7.0 Planning Comments Response

7.1 Changes Described

7.2 Updates to Site-plan

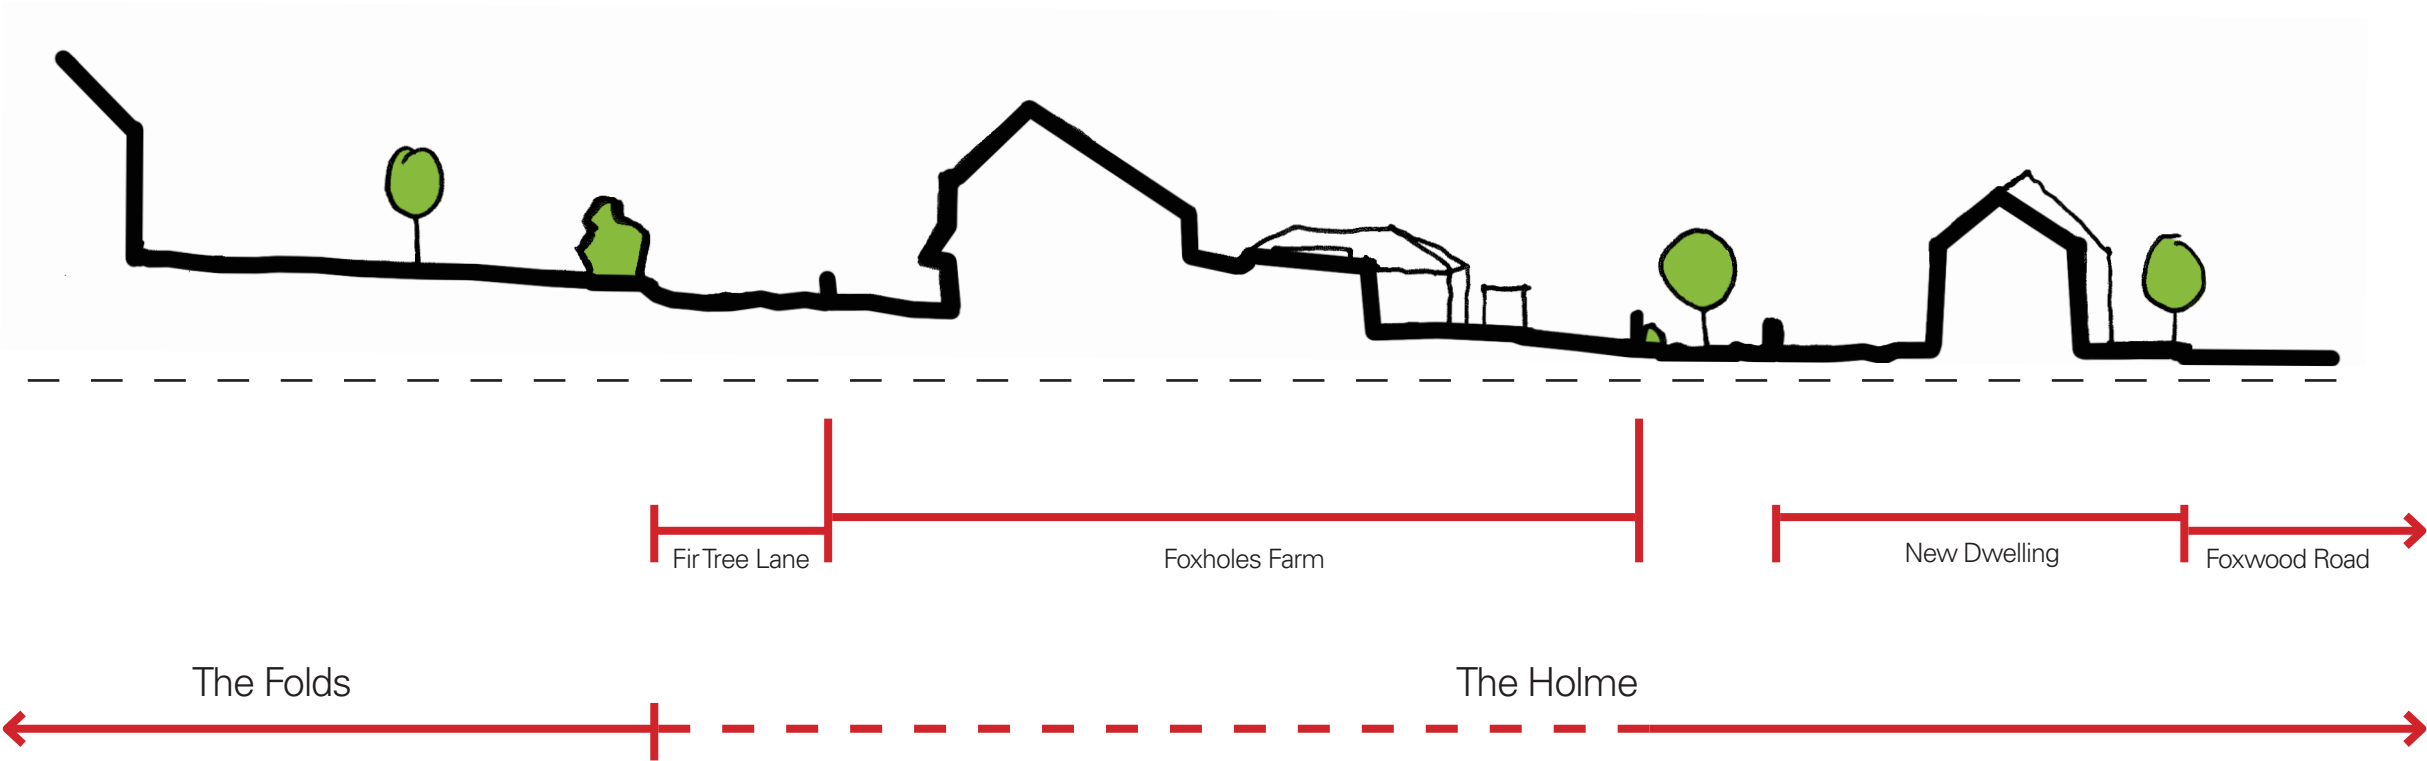
In response to the planning officer comments we have proposed making several changes to the masterplan.

Urban Design Response

- 1. Rotated houses to have front doors onto Foxwood Road
- 2. Moved front doors on houses onto Foxwood Road (New or alternative house type)
- 3. Improved Southern elevations on southern most dwellings to better address the entrance to Homestal (Alternative house type)
- 4. Introduced a 3-storey dwelling to add vertical variety and help with stepping from 2 to 4 storeys (New house type)

Highways Response

- 5. Amended road profile to allow for easier passing
- 6. Adjusted road width for easier access to parking

Landscape Response

- 7. Amended landscape strategy and path layouts following comments
- 8. Adjusted junction layout and surface treatment following comments
- 9. Tree buffer intensified
- 10. Tree Locations adjusted. *Adjusted generally across whole masterplan Not limited to specific location
- 11. New Hedges to Northern street in front of dwellings
